Landscape Review Committee Community Development Center, 231 NE 5th Street July 19, 2017 12:00 PM

DATE:July 19, 2017TO:Landscape Review Committee MembersFROM:Chuck Darnell, Associate PlannerSUBJECT:Agenda Item 4A: L 21-17

An application for a landscape plan for a redeveloped portion of an existing industrial site and facility (L 21-17) to be reviewed by the Landscape Review Committee. This plan was revised based on comments provided by the Landscape Review Committee at the June 21, 2017 meeting.

RE: Willamette Haze – Landscape Comments Response Letter 1439 NE Lafayette Avenue., McMinnville, OR Application No. (L 21-17)

6/30/2017 8:51:41 AM //civil-server/projects/1775001 Willamette Haze/Dgn/L01Planting

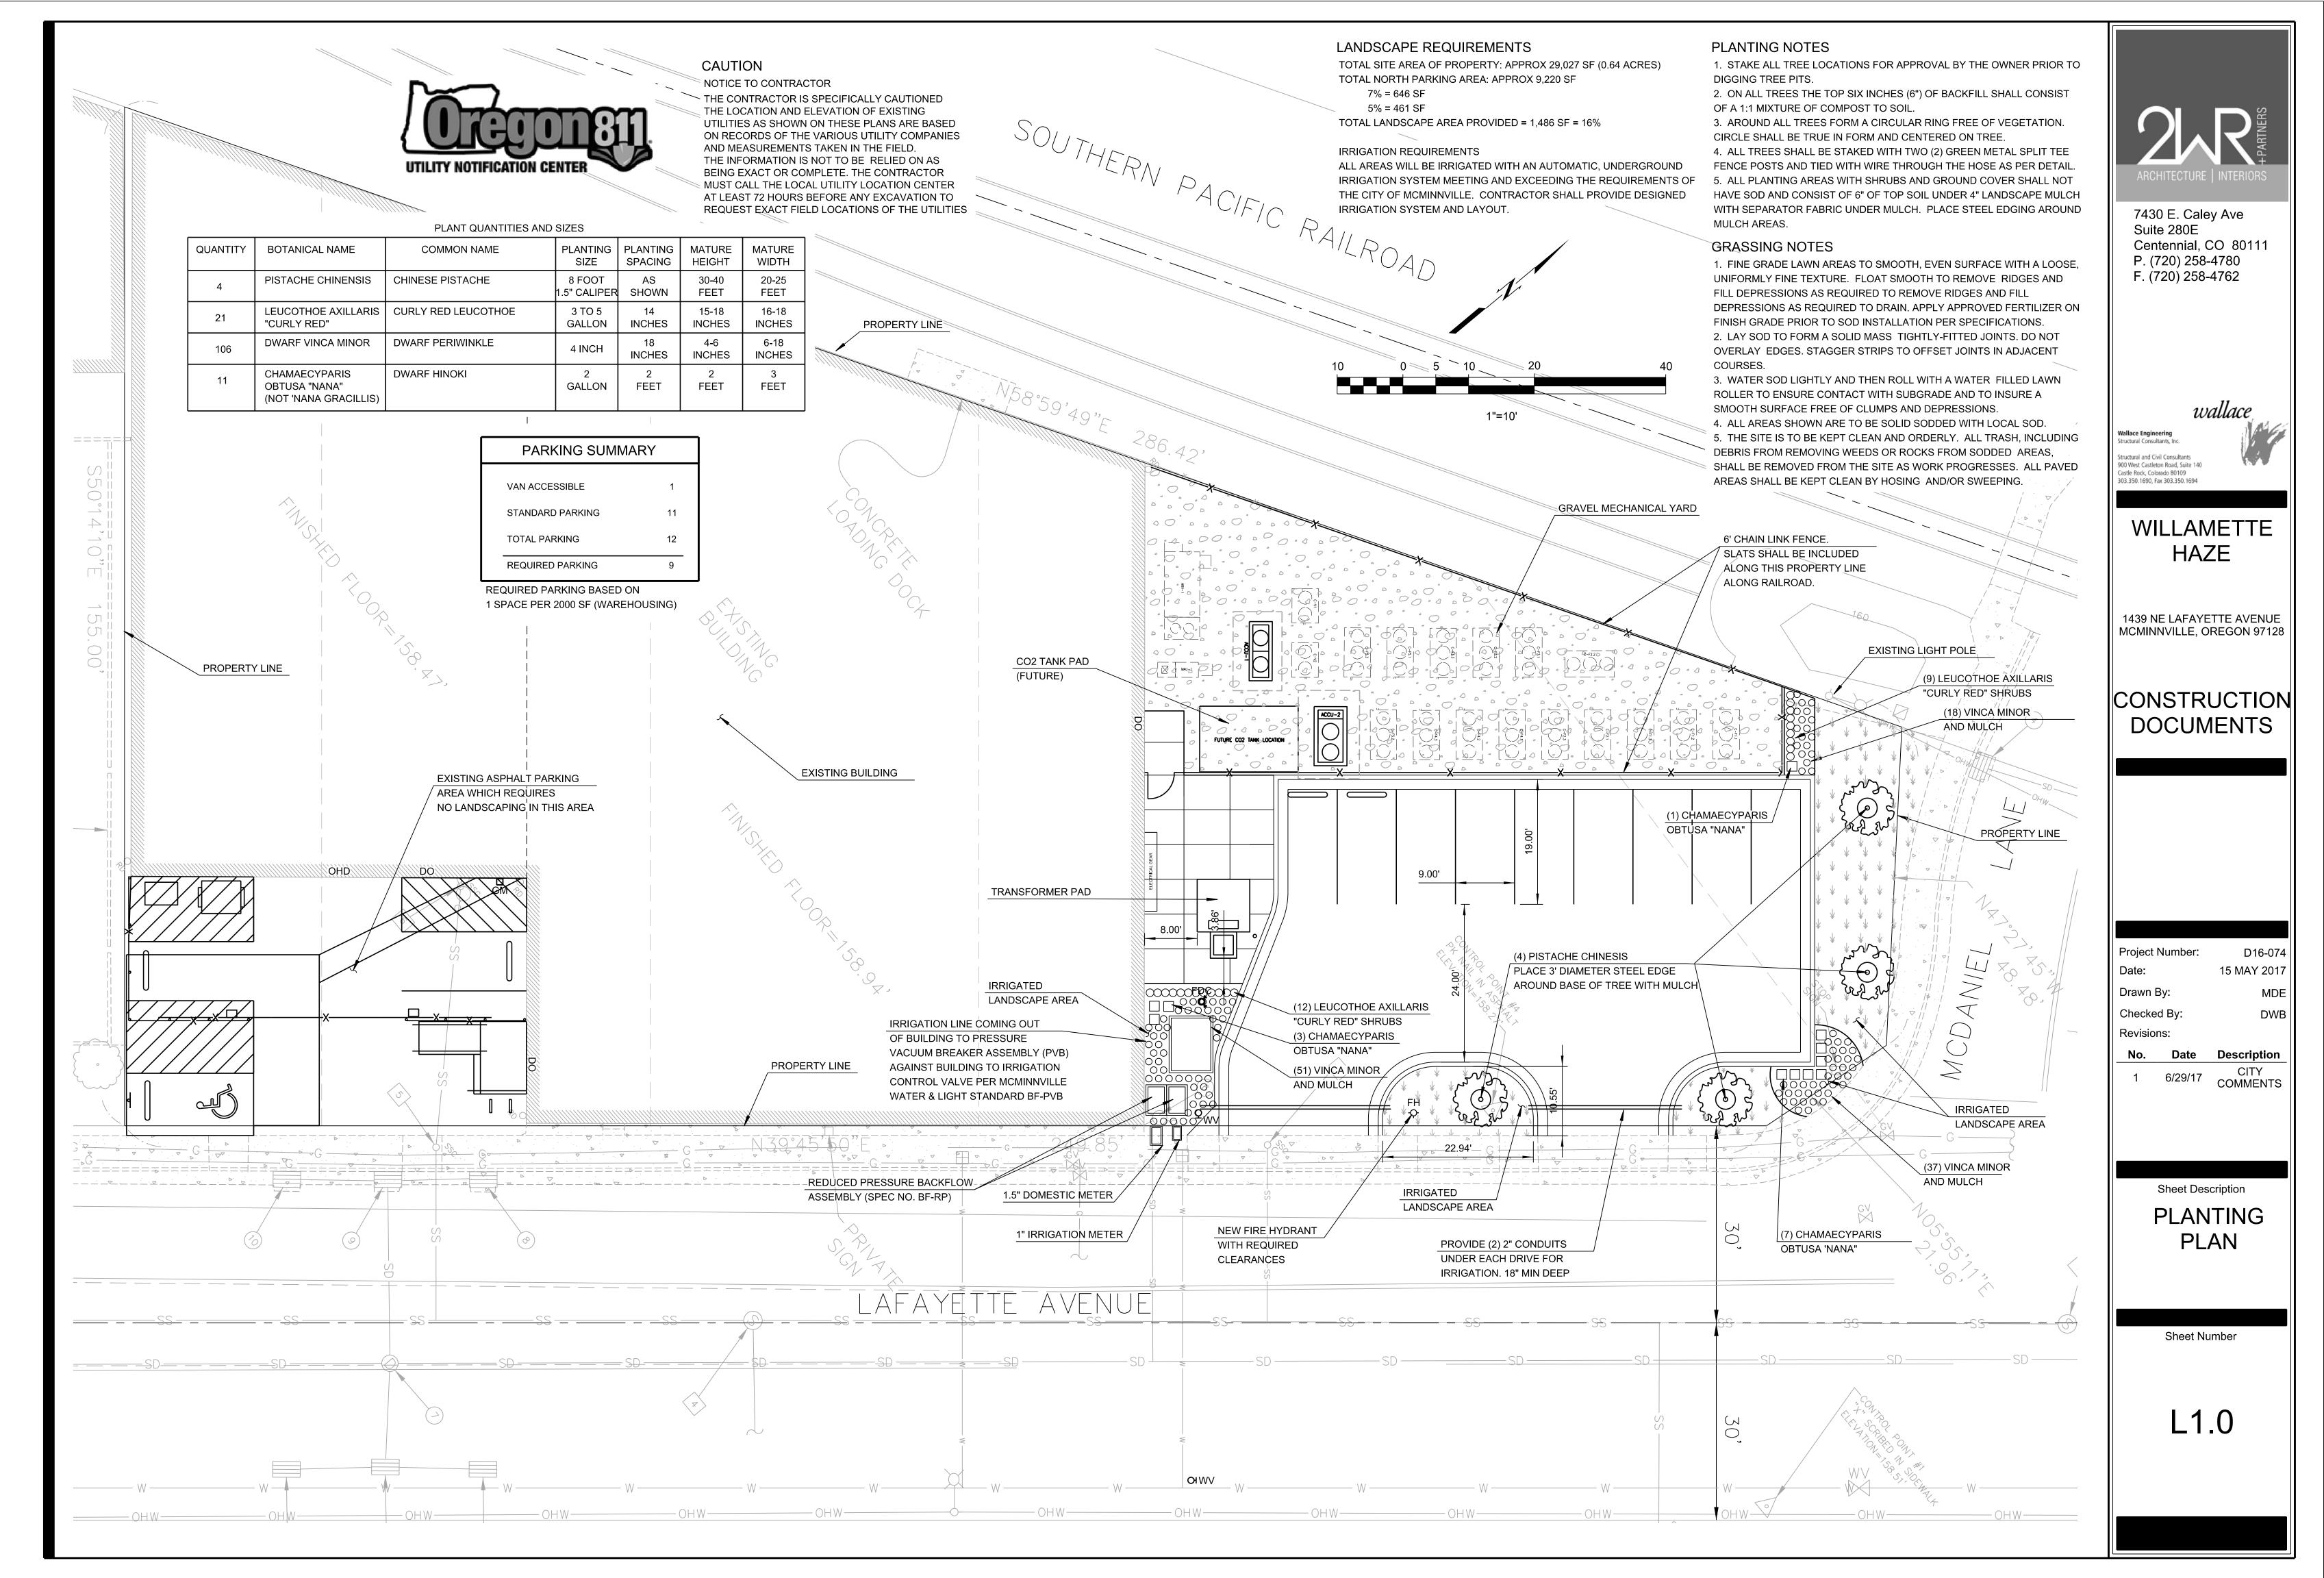
- 1) The Committee did not believe that the proposed Japanese Maple trees would provide adequate screening of the site. The Committee suggested that, in place of the Japanese Maple trees, the applicant use a tree from the McMinnville Street Tree List.

- 2) The Committee did not believe that the proposed Lithodora would survive well as a ground cover in this climate. The Committee suggested that the applicant choose a different ground cover more suited to this area such as a Dwarf Vinca Minor.

- 3) The Committee was not comfortable with the spacing of the shrubs and groundcover as shown on the landscape plan, based on the proposed spacing and the mature plant widths. The Committee suggested that the applicant review the proposed spacing standards for the identified plant material, and either revise the spacing or provide reasoning for the proposed spacing.

- 4) Staff had suggested that a condition of approval be included to require fencing around the entire gravel mechanical yard. The Committee stated that they would likely support that as a condition if the application is approved next month. The applicant could add that fencing to the landscape plan if revisions were going to be made.

The applicant also revised the proposed chain link fence around the gravel mechanical yard. The revised landscape plan now shows the six (6) foot chain link fence around the entire perimeter of the gravel mechanical yard. However, they are only showing slats to be installed in the fence along the property line that is adjacent to the railroad. Staff's original intent was that the chain link fence be

installed to provide for additional screening of the mechanical yard. Therefore, staff is still recommending a condition of approval that slats be installed in the chain link fence along the entire perimeter of the mechanical yard.

The applicant is proposing to install four (4) Chinese Pistache (*Pistacia chinesis*) trees, in place of the previously proposed Coral Bark Japanese Maple (*Acer palmatum* 'Sango Kaku') trees. Chinese Pistache trees are a species listed on the McMinnville Street Tree List. These trees will grow to a mature height of 30 to 25 feet and a mature width of 25-30 feet. The height and width of these trees is greater than the previously proposed Coral Bark Japanese Maple trees. Based on the proposed spacing of the trees and the mature width, the trees should grow to provide a full canopy on the McDaniel Lane frontage of the site.

On the corner of the property near the intersection of NE Lafayette Avenue and NE McDaniel Lane, the applicant was proposing to install a landscaped planter area with smaller evergreen shrubs (*Leucothoe axillaris* 'Curly Red') and smaller low-growing plants for groundcover (*Lithodora diffusa* 'Heavenly Bamboo'). Additional landscaped areas with identical plant materials will be installed on the east side of the mechanical yard, and on the west side of the parking lot around other utilities and transformers near the building. The committee has concerns with the use of Lithodora and had suggest that the applicant use a plant material more suited to this climate such as Dwarf Periwinkle. The applicant has replaced the previously proposed Lithodora with Dwarf Periwinkle (Dwarf *Vinca minor*).

In terms of the spacing of the proposed plant materials, the applicant adjusted the spacing on the plan and in the planting table to show plant spacing that better coincided with the mature width of the plant materials.

- The Lighodora was replaced with the requested Dwarf Vinca Minor.
- 3) The Committee was not comfortable with the spacing of the shrubs and groundcover as shown on the landscape plan, based on the proposed spacing and the mature plant widths. The Committee would like the applicant to review the proposed spacing standards for the identified plant material, and either revise the spacing or provide reasoning for the proposed spacing.

- *Additional plantings were provided with the requested reduced spacing.*
- 4) Staff had suggested that a condition of approval be included to require fencing around the entire gravel mechanical yard. The Committee stated that they would likely support that as a condition if the application is approved next month. The applicant could add that fencing to the landscape plan if revisions are being made.

۰. **X** . × ··· × ···· × · X LANDSCAPE PLAN FUR PRAN KUMUS RIVERSIDE STOKAGE ZOIT A-DDITTION 1615 EIVERSIDE DAIVE IMPRUVED AREA 70,000 SQFT

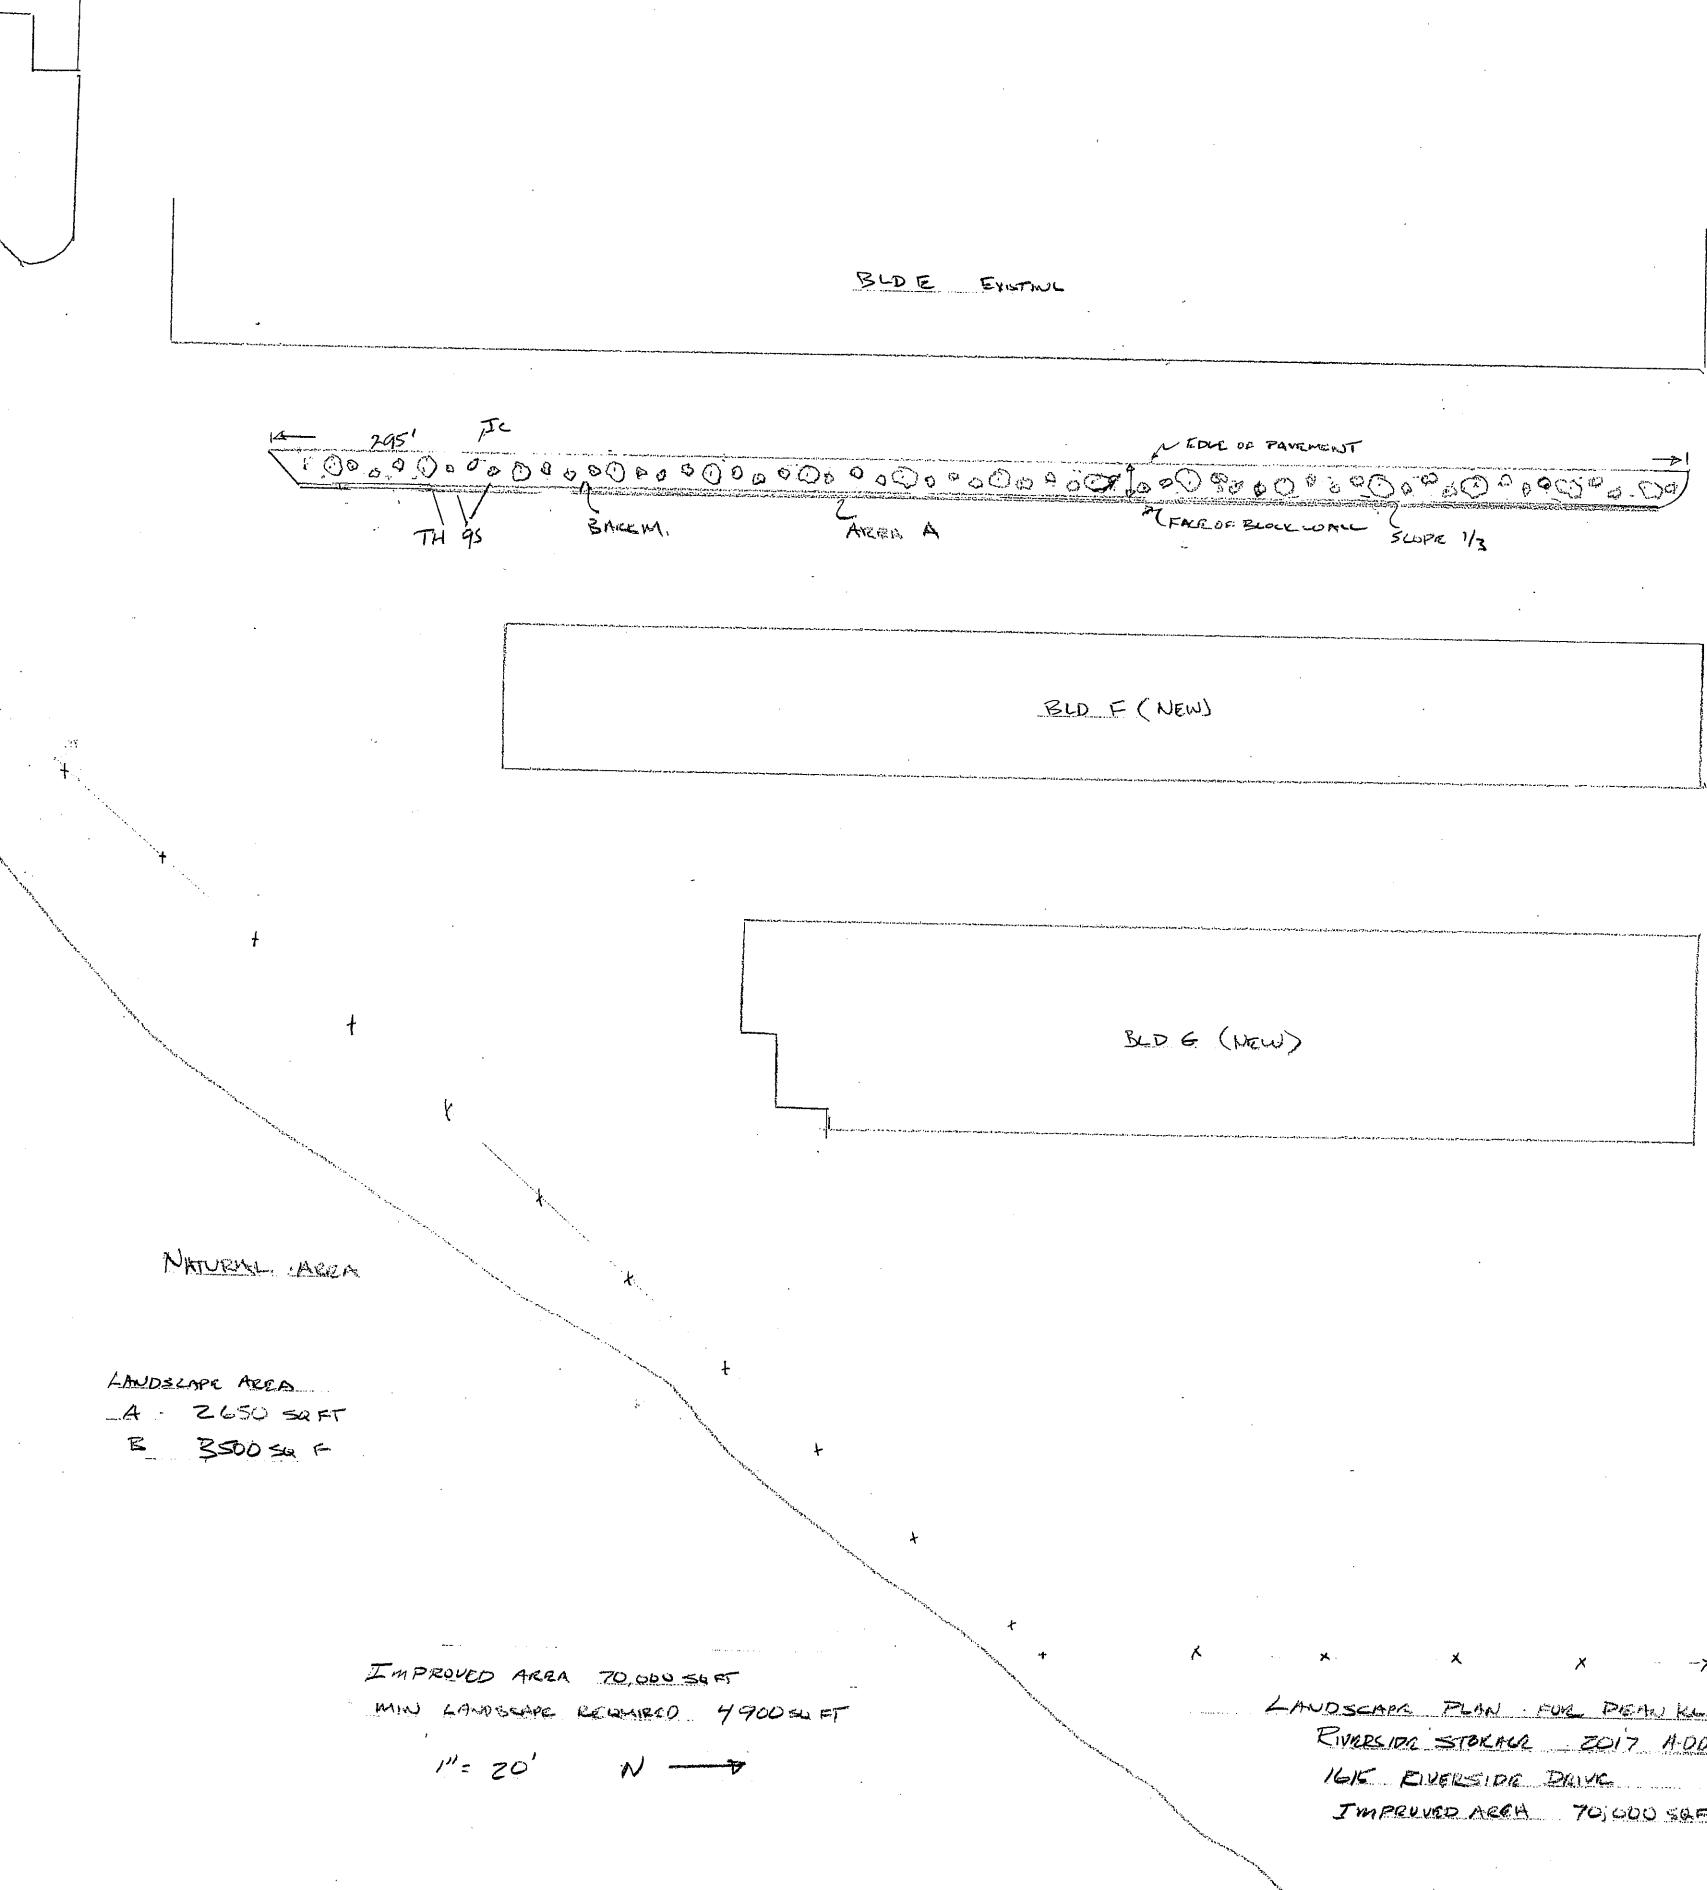
No irrigation facilities are proposed on the landscape plan submitted. Staff is suggesting a condition of approval to require that irrigation or suitable watering facilities be included in the proposed planter areas.
